GC0155

Clarification of Fault Ride Through Technical Requirements

Meeting 2

07 June 2022

Figure 2 showing a fault which can be cleared by transmission system breakers TCB3 & 4

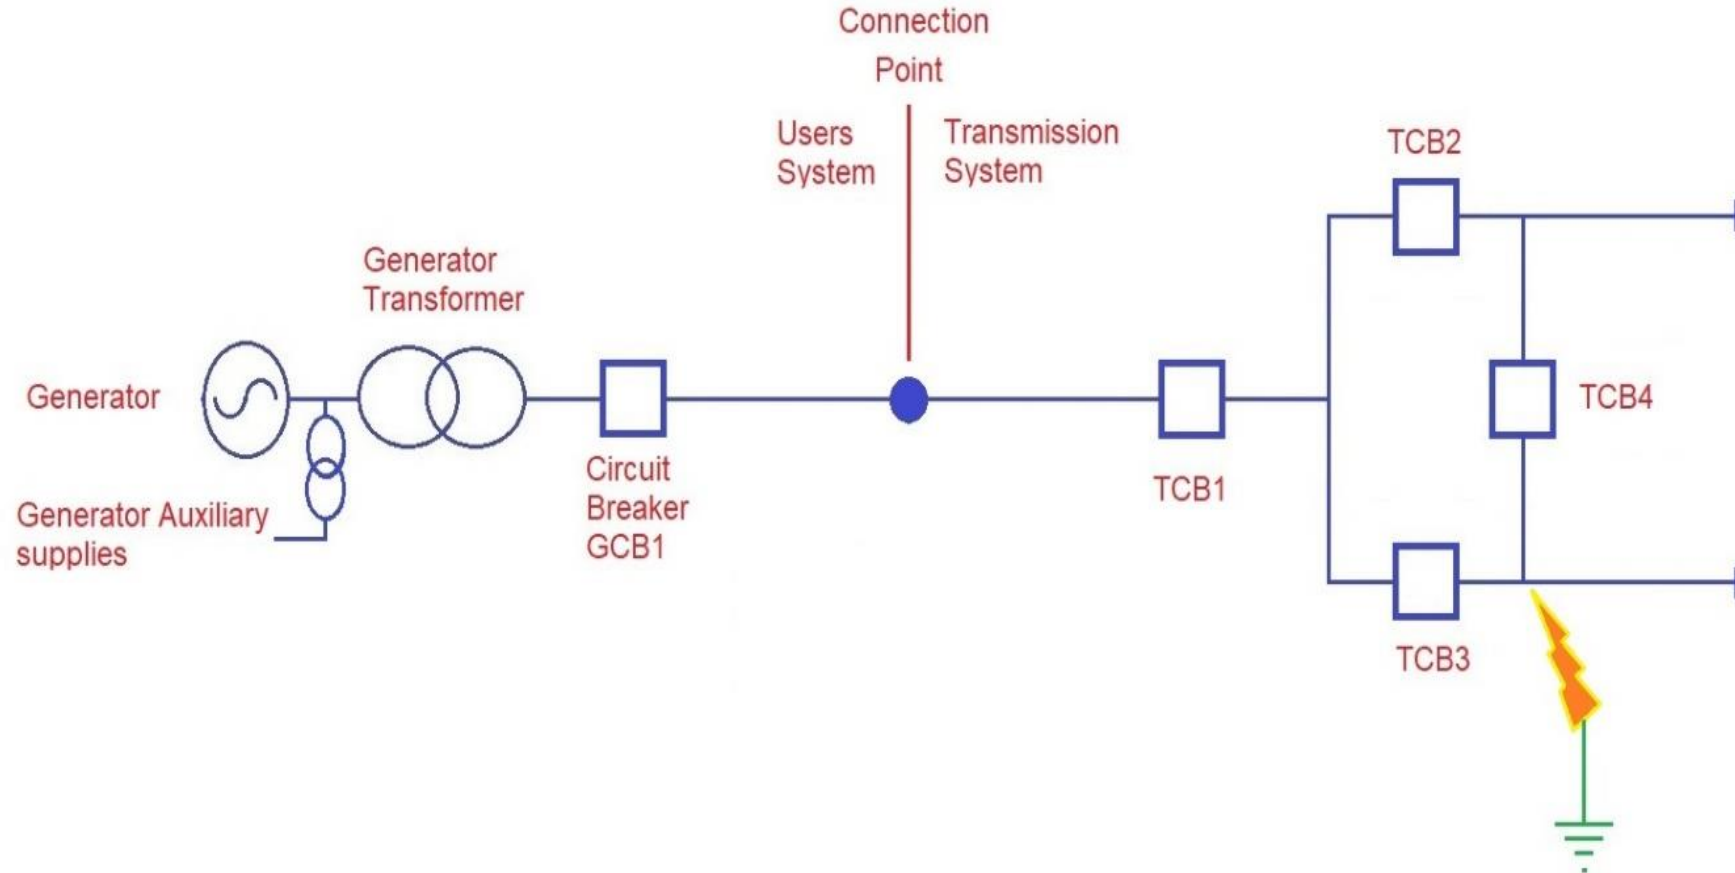
The new section CC.6.3.15(a)(i)(b) will specify the actions to be taken if a fault occurs by requiring that plants ride through faults in the transmission system which can be cleared by the transmission system circuit breaker as shown in figure 2 below and by adding the following text as the introduction to the section

- (b) Each **Generating Unit, DC Converter, or Power Park Module** and any constituent **Power Park Unit** thereof and **OTSDUW Plant and Apparatus** shall remain transiently stable and connected to the **System** without tripping of any **Generating Unit, DC Converter or Power Park Module** and / or any constituent **Power Park Unit, OTSDUW Plant and Apparatus**, and for **Plant and Apparatus** installed on or after 1 December 2017, reactive compensation equipment, for any balanced and unbalanced fault where subjected to a voltage dip at either the **Onshore Grid Entry Point** or **Interface Point** as applicable where the voltage remains either on or within the envelope shown in figure CC.6.3.15(a)(i)(a) except where:

Figure 3 showing a fault which can only be cleared by generator breakers GCB1

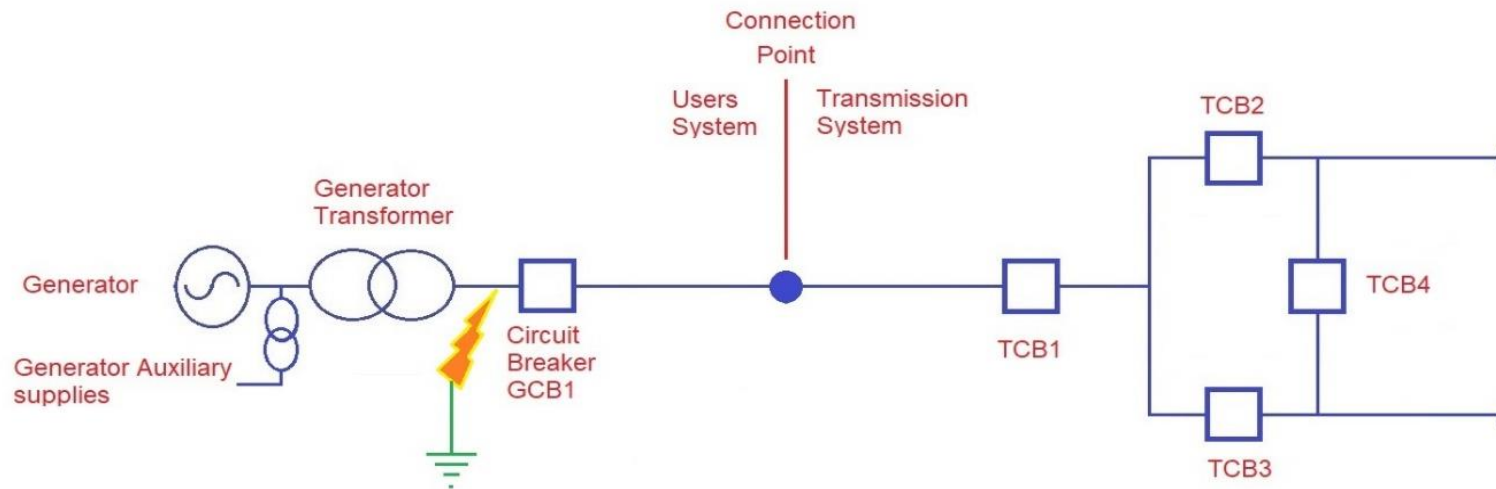
Whilst the introduction deals with plants riding through faults as it is currently drafted in the Grid Code, it is not clear what is supposed to happen where the plant's circuit breaker has to open to clear the fault.

There are concerns that the current text could be interpreted that the plant shall remain connected feeding the fault for 140ms which could lead to dangerous situations. It is clear this is not the intent, and that plant should trip during these circumstances.

If the fault is on the Generator's equipment then the Generator shall be required to trip to clear the fault from the transmission system as detailed in the proposed new section CC.6.3.15(a)(ii)(b)(i) (note that this is already permitted in the ECCs), as follows:-

Power Park Module and any constituent **Power Park Unit** thereof and **OTSDUW Plant and Apparatus** shall trip to clear the fault from the **Transmission System**. The protection schemes and settings should not jeopardise **Fault Ride Through** performance as specified in CC.6.3.15.1

Figure 4 showing a fault which can only be cleared by generator breaker GCB1 & transmission circuit breaker TCB1

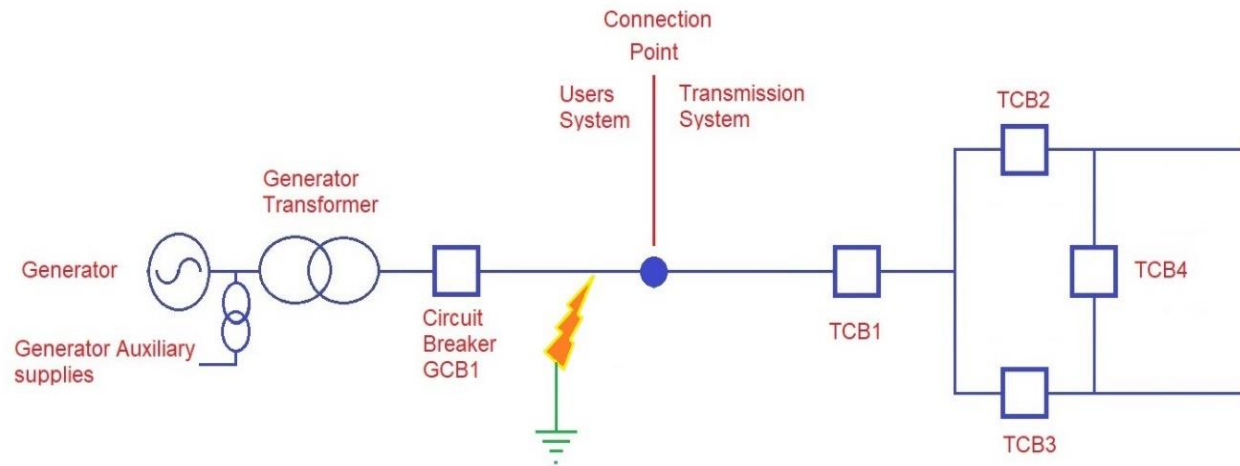
If the location of the fault on the network that means that the fault can only be cleared by operation of both Transmission and the Generator circuit breaker as shown in figure 4, again the Generator will be permitted to trip to clear the fault as detailed in the proposed new section CC.6.3.15(a)(i)(b)(ii) and ECC.6.3.15.8(vi)(i), as follows:-

the location of the fault means it cannot be fully cleared without tripping the of **Generating Unit, DC Converter, or Power Park Module** and any constituent **Power Park Unit** thereof and the **OTSDUW Plant** shall trip as required.

Figure 5 showing a fault which can be cleared by transmission breakers TCB1,2&3, however this results in the Generator being islanded from the main transmission system and needs to come off

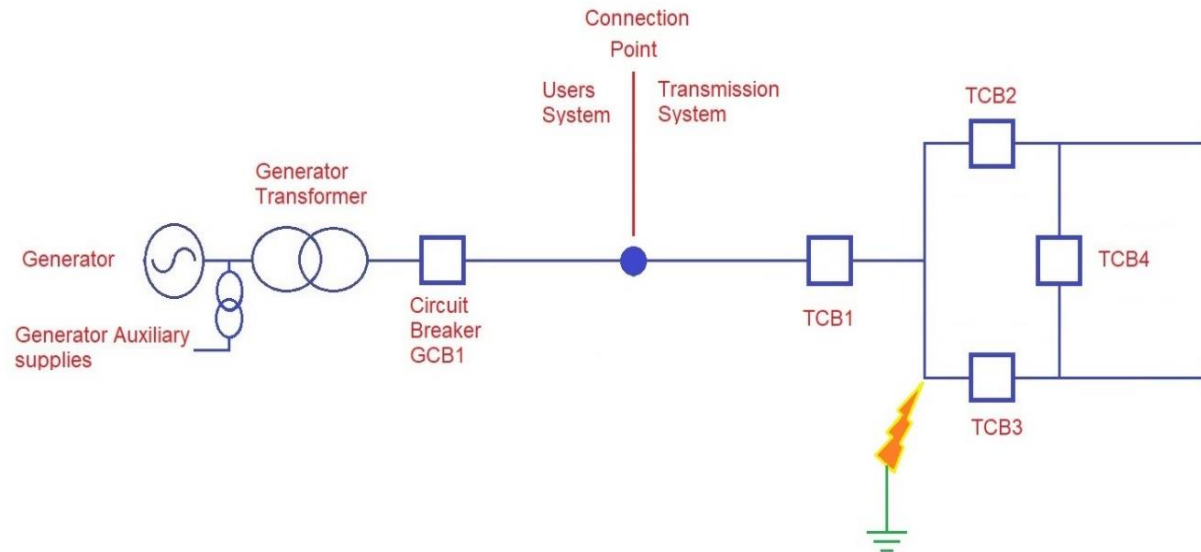
if the location of the fault on the network means that the Generator will become islanded by the operation of the transmission circuit breakers as shown in figure 5 then it shall be permitted to trip as detailed in the proposed new sections CC.6.3.15(a)(ii)(b)(iii) and ECC.6.3.15.8(vi)(ii), as follows:-

clearance of the fault results in the **Generating Unit, DC Converter, or Power Park Module or OTSDUW Plant** becoming islanded and disconnected from the **Total System** and not supplying **Customers** (where CC.6.3.7(c)(i) applies), then the **Generating Unit DC Converter or OTSDUW Plants** shall be permitted to trip as required.

Figure 6 showing an interpretation of the existing legal text requiring the current to either be in the green box or on the red line

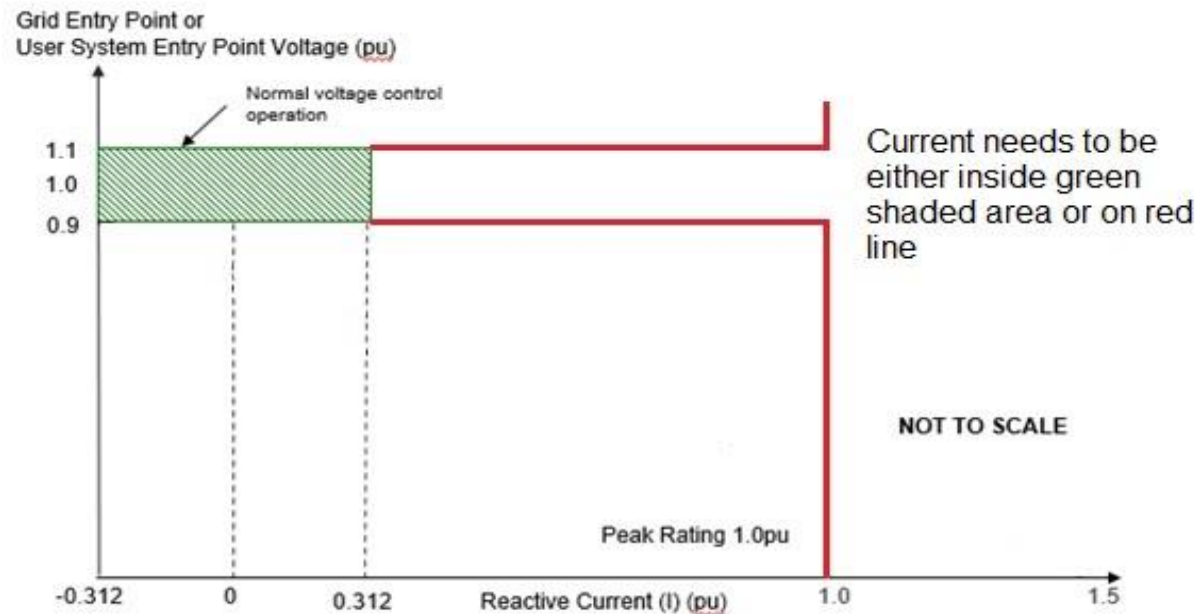
The area of the current legal text which technically creates the biggest problem in relation to compliance are in sections CC.6.3.15 (a)(ii) and ECC.6.3.15.9.2.1(a)(i) which currently state "for which the voltage at the Grid Entry Point (or Interface Point in the case of OTSDUW Plant and Apparatus) is outside the limits specified in CC.6.1.4, each Generating Unit or Power Park Module or OTSDUW Plant and Apparatus shall generate maximum reactive current". If this requirement is drawn out on the figure 6 below where the current and voltage must always either be within the green shaded area or on the red line.

Figure 8 showing a typical active power response of a unit at low load to a fault

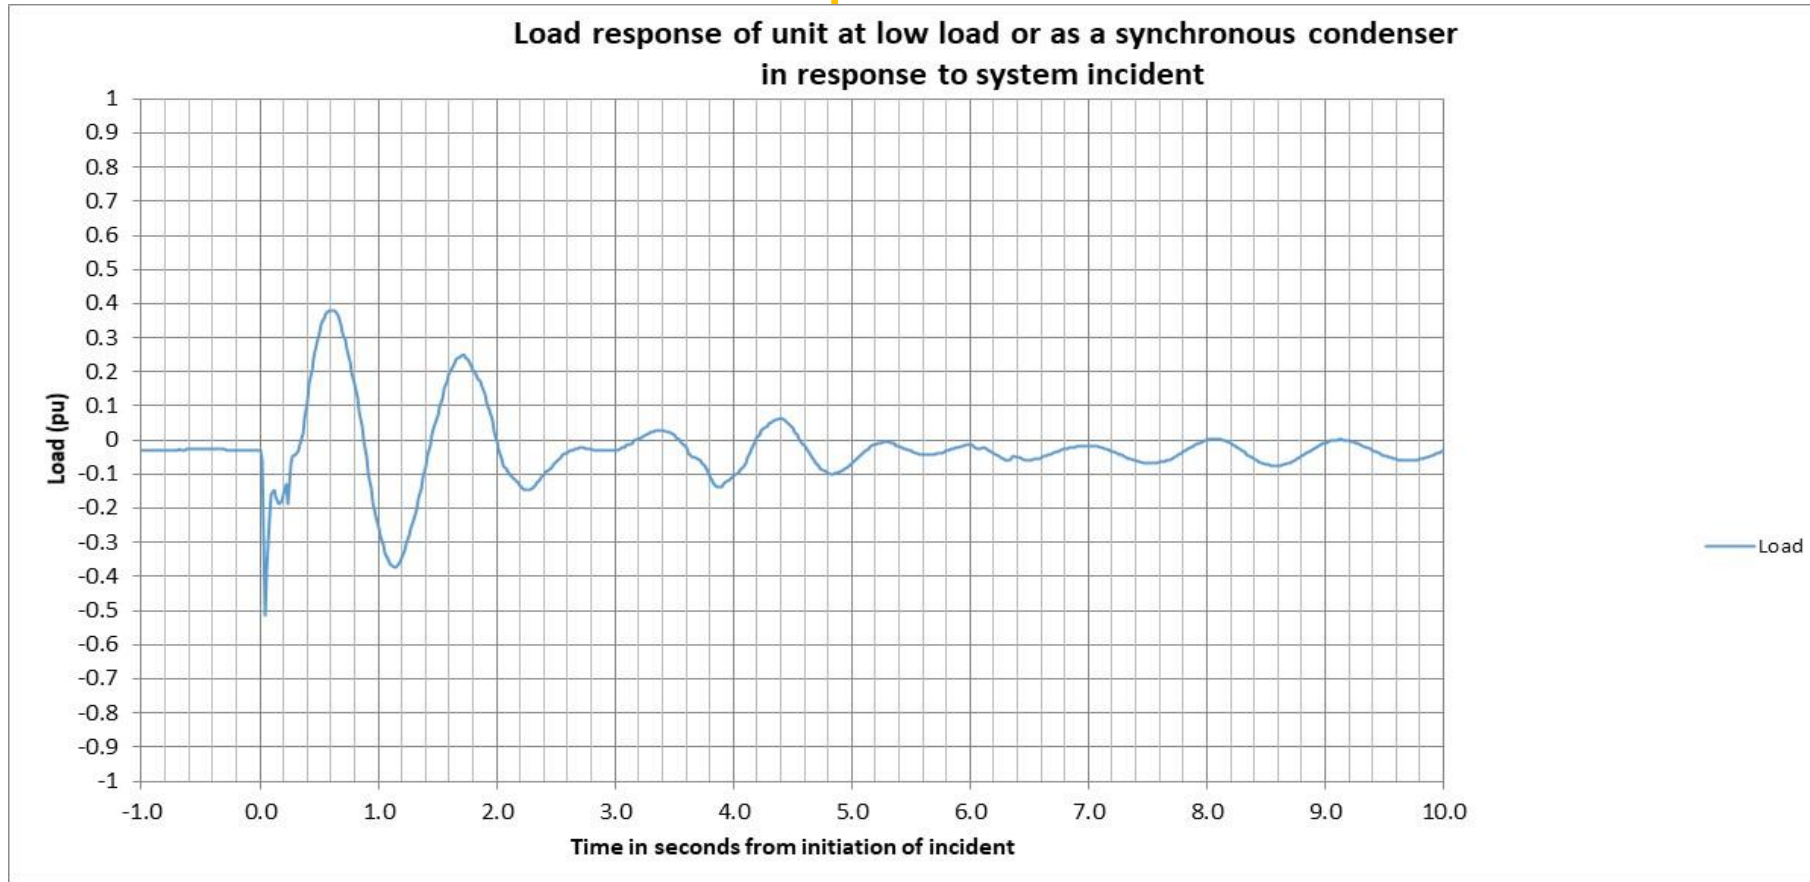
Whilst this works in principle at higher loads, it does create an issue at lower loads if you consider a real event for a unit operating as a synchronous condenser in figure 8.

If you look at the initial load which is 0.02 pu then 90% of this small number you get a very small number, it is also difficult to see how a sensible compliance assessment can be carried out at these levels and it is hence suggested that under these circumstances the tolerance should be changed.
